NPP DAMPIERRE 3&4 LTO ENVIRONMENTAL IMPACT ASSESSMENT

Expert Statement

Contracting authority Federal Ministry of Agriculture and Forestry, Climate and Environmental Protection, Regions and Water Management; Directorate General VI - Environment and Climate; Directorate VI/8 General Coordination of Nuclear Affairs

Figure 3: French active fault database and location of the Dampierre reactors (redrawn from: JOMARD et al. 2017; RITZ et al. 2021). Circles around Dampierre indicate the site near-region and site region according to IAEA (2022) (radius 25 and 50 km from the site, respectively).

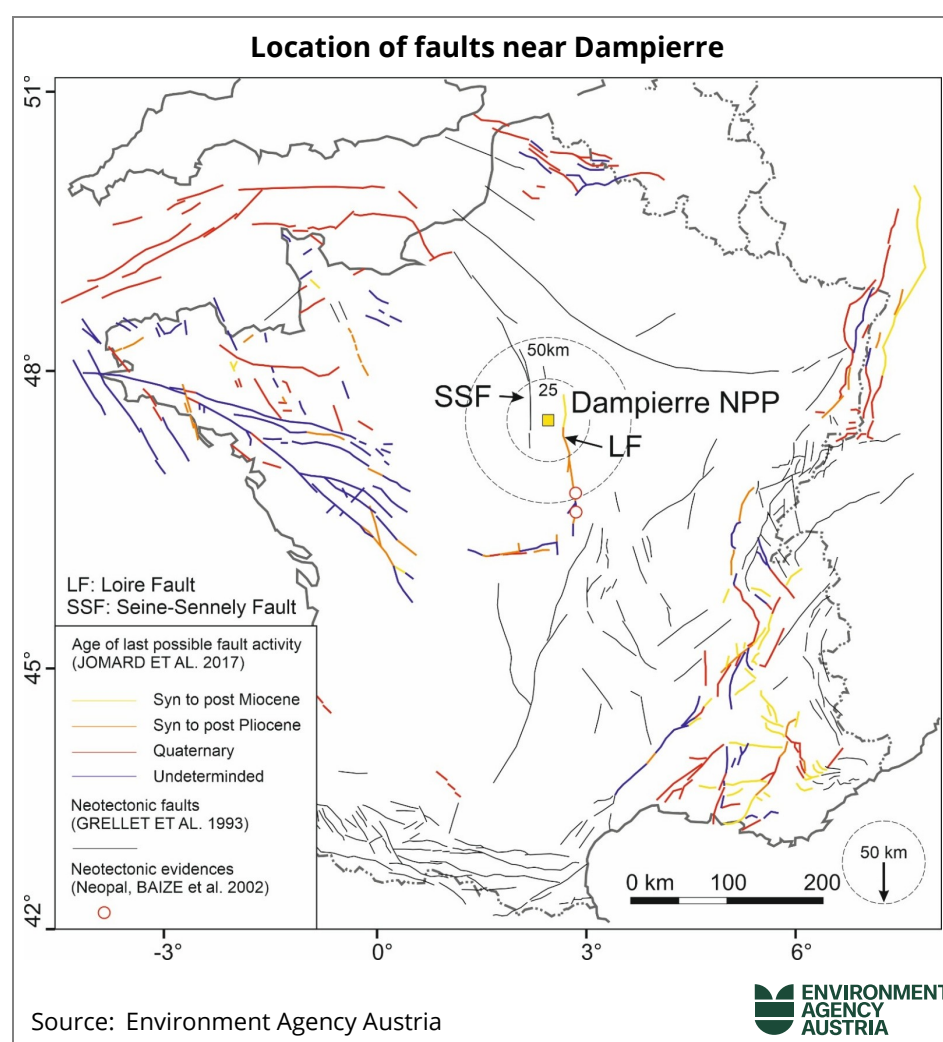
In tectonic terms, the Dampierre site is located in the Paris Basin, a sedimentary basin filled with more than 3 km thick sediments of Permian to Neogene age (e.g., GUILLOCHEAU et al. 2000). The basin is crossed by a number of faults including the Loire and Seine-Sennely fault systems which pass the NPP site at distances of less than about 25 km (Figure 3).

For the Loire fault, JOMARD et al. (2017) infer a syn- to post-Pliocene age for the latest fault movement (ca. 5 to less than 2.6 million years). The NEOPAL database (BAIZE et al. 2002)¹¹ lists two locations at or near the Loire fault for which geological data indicate late to post-Pliocene faulting (Figure 3; CLOZIER & GROS 1985). According to the IAEA (2022), seismic hazard analysis in areas of low seismicity, such as the Paris Basin, should take into account faults of this age.

EIA-REPORT D3, P.2 (2026, p. 134) and EIA-REPORT D4, P.2 (2026, p. 134) provide evidence that EDF is aware that geological and tectonic data prove the existence of several faults in the near-region¹² and region around the Dampierre site, naming the Sennely, Etampes, Sully-sur-Loire and Sancerre fault. EDF already started investigating these faults by literature review and mapping of industrial reflection seismic and reports plans to further investigate the faults with geophysical and paleoseismological methods (EIA-REPORT D3/4, P.2 2026, p. 155/148). These plans are appreciated. EIA documents, however, do not include a tangible time schedule for the investigations announced in the EIA documents.

Figure 6: Cloud arrival time for the release category FK2

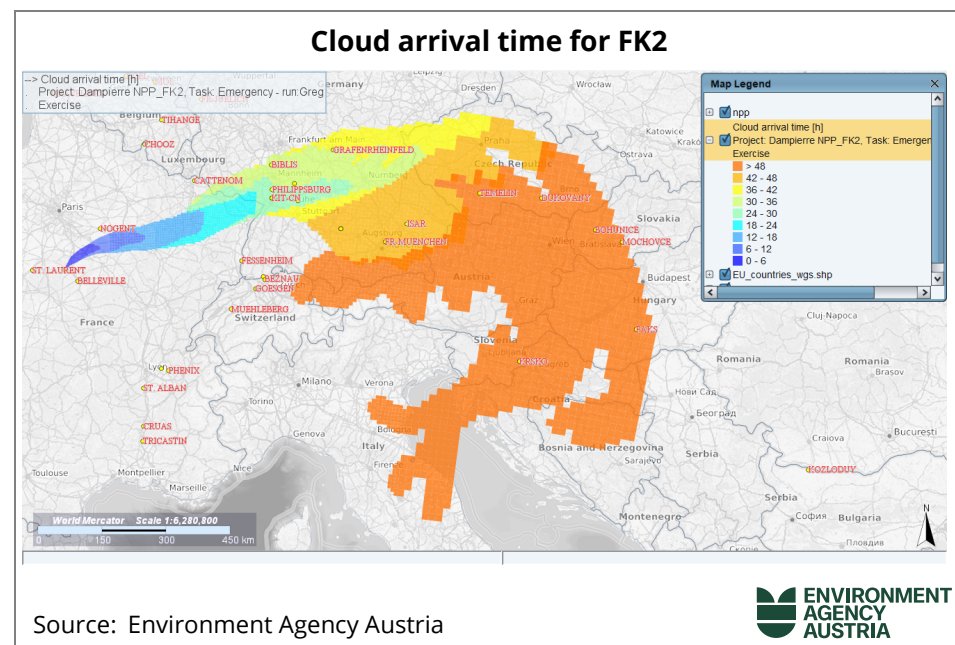
Figure 6 presents information on cloud arrival time, indicating when the radioactive cloud is expected to reach the affected country. In both scenarios, with the release assumed to start on 3 August 2025 at 18:00 UTC, the cloud is projected to reach Austrian territory in 48 hours. Meteorological conditions are the dominant factor influencing cloud arrival time, and this result may vary significantly under different weather conditions.

Figure 7: Ground contamination with Cs-137 for the release category FK2

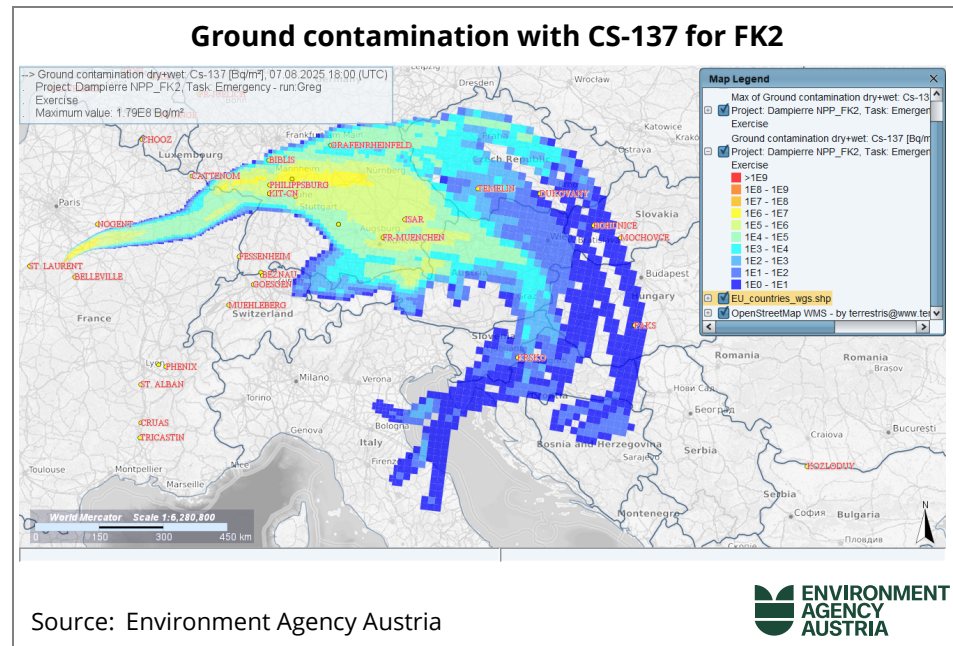
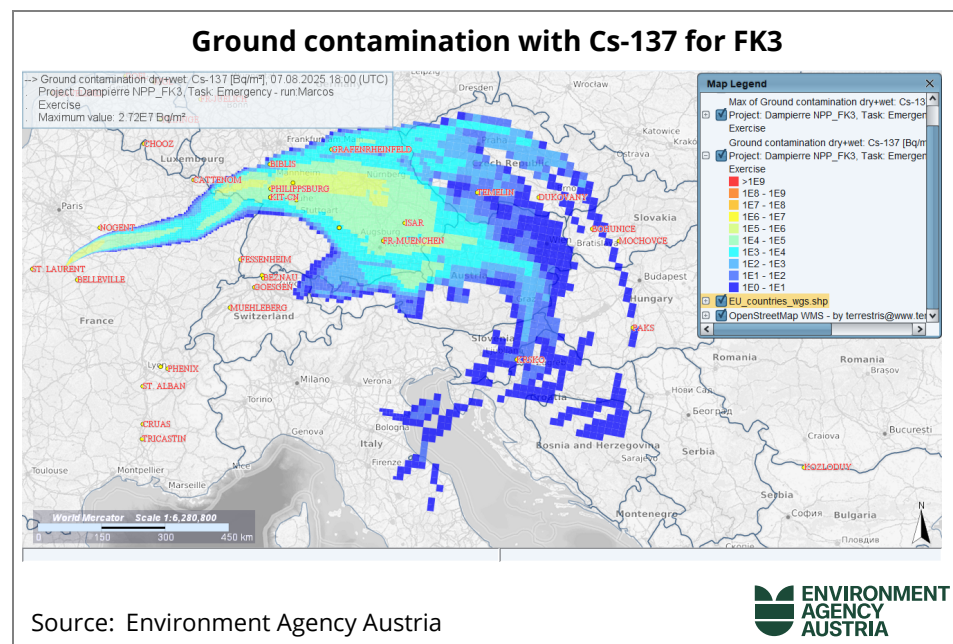
Deposition of the radioactive material released in an accident depends on a number of factors: characteristics of a release, including particle size distribution, meteorological conditions, deposition surface and others. The results of the JRODOS calculations performed by the expert team for release categories FK2 and FK3 are presented in Figure 7 and Figure 8.

The results of the JRODOS calculations demonstrate that contamination levels in Austria exceeding 650 Bq/m² are possible. The maximum calculated ground deposition exceeds 1×10^5 Bq/m² for release category FK2 and 1×10^4 Bq/m² for release category FK3.

These results indicate that transboundary radiological consequences more significant than those presented in the EIA documents cannot be
